SERVICE BULLETIN

SUBJECT: Norco, Inc. Thrust Reverser Hold Open Rod - Check Inner Rod Retaining Screw

A 2972-78-1

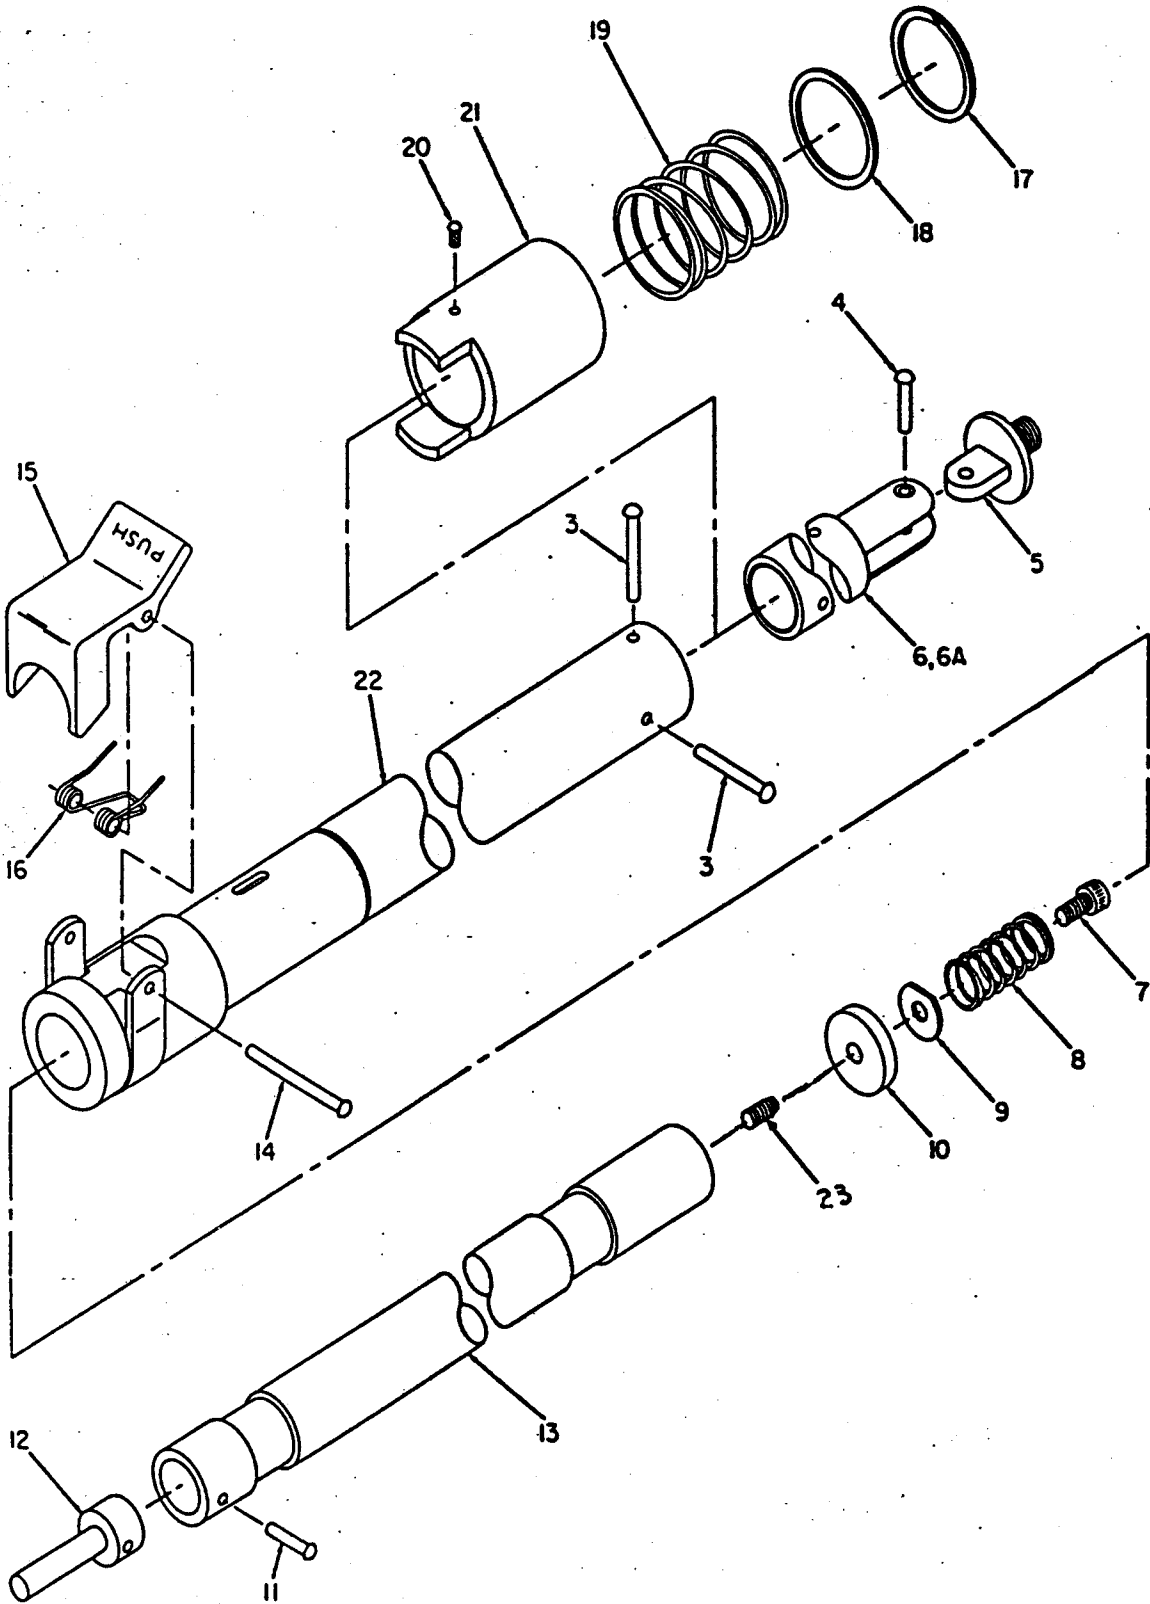
Refer to Fig. 1 for item Identification.

- 1) Remove the two rivets (3) from the outer tube assembly (22).
- 2) Remove the clevis end plug (6 or 6A), with clevis fitting (5) and rivet (4) attached, from the outer tube assembly (22).

- 3) Push inner rod assembly (13) fully to the rear of outer tube assembly (22).
- 4) While holding end fitting (12) in a soft jawed vice, insert a 5/32 hex wrench into the rear of tube assembly (22). Unscrew and remove socket head cap screw (7) from flat washer (9), spacer (10) and discard these components.
- 5) Remove inner rod assembly (13) by pulling it forward through the front of tube assembly (22).

FIG. 2

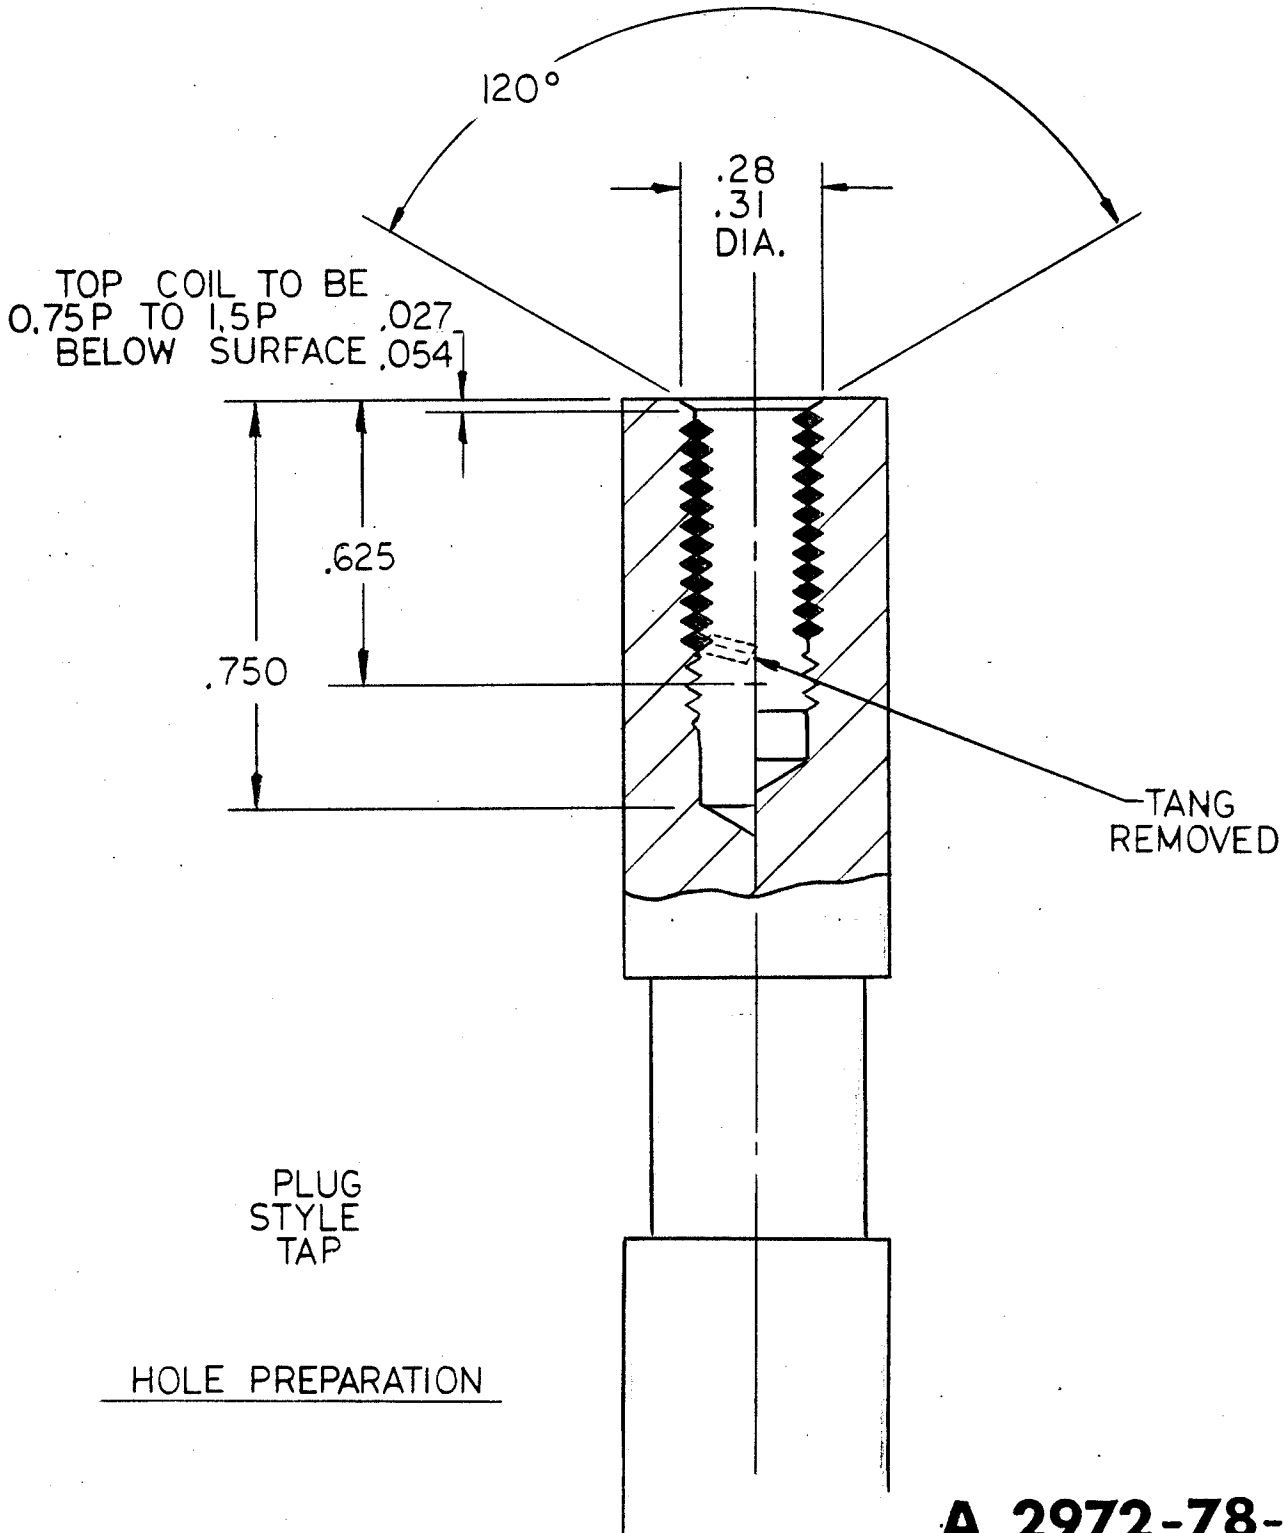
The above serial numbers may be upgraded with larger retaining screw and helicoil insert to prevent the inner rod retaining screw from working free due to vibration or excess force, letting the inner rod be pulled from the assembly.

B. Rework Instructions - (See Fig. 2)

- 1) Install inner rod in a lathe so that access to the existing 10/32 threaded hole is available.
- 2) Drill .261 dia. x .750 deep.
- 3) Countersink 120 \pm 5 x .28/.31 dia.
- 4) Tap with helicoil STI Tap #4FPA-H3 x .625 min. full thread.
- 5) Install helicoil screw lock insert P/N MS21209-F4-20 with helicoil tool No. 7552-4.
- 6) Break off driving tang with helicoil tang break off tool #3695-4.
